SIB 51 11 25

UNABLE TO UNLOCK THE HOOD USING THE RELEASE LEVER

2026-09-21

This Service Information Bulletin (Revision 1) replaces SI B51 11 25 **dated July 17, 2026**.

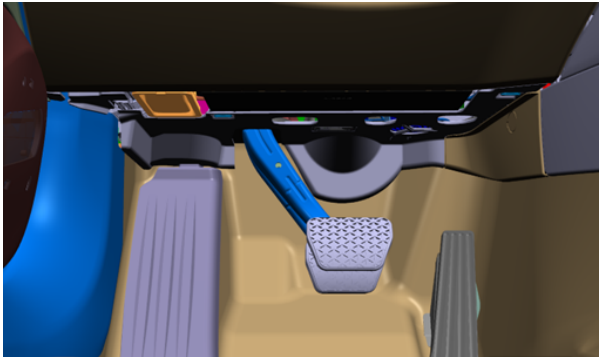
When pulling on the hood (**highlighted in orange in the top photo**) release lever (**highlighted in orange in the bottom photo**; driver’s footwell shown), there is a noticeable lack of cable tension; and the hood will not unlock.

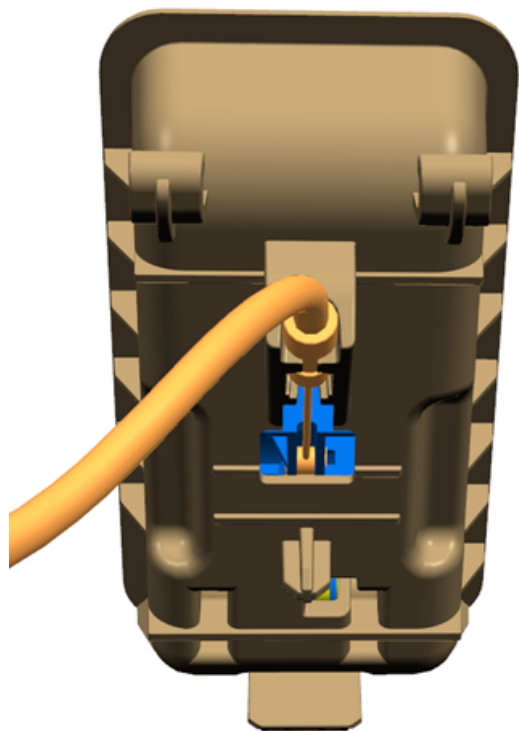
The Bowden cable (**highlighted in orange**) in the release lever becomes unclipped.

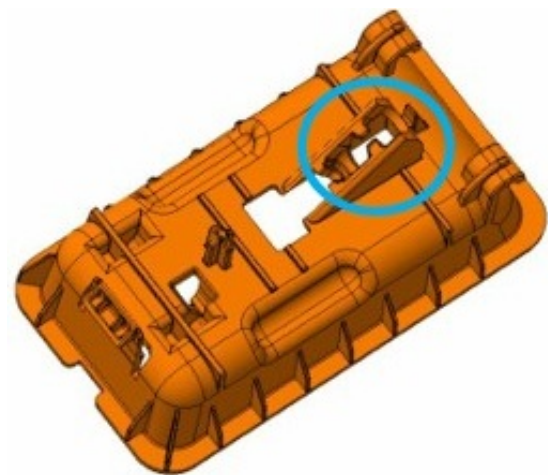
The updated component, part number **51 23 5 B89 DF8**, supersedes the previous version. The revisions are identified by the blue circles in the image.

- 1. Lower the Driver trim panel for the pedal assembly according to **REP 51 45 184** and replace Hood Bonnet lever.
- 2. Once repair is completed, reassess the operation of the Hood lever.
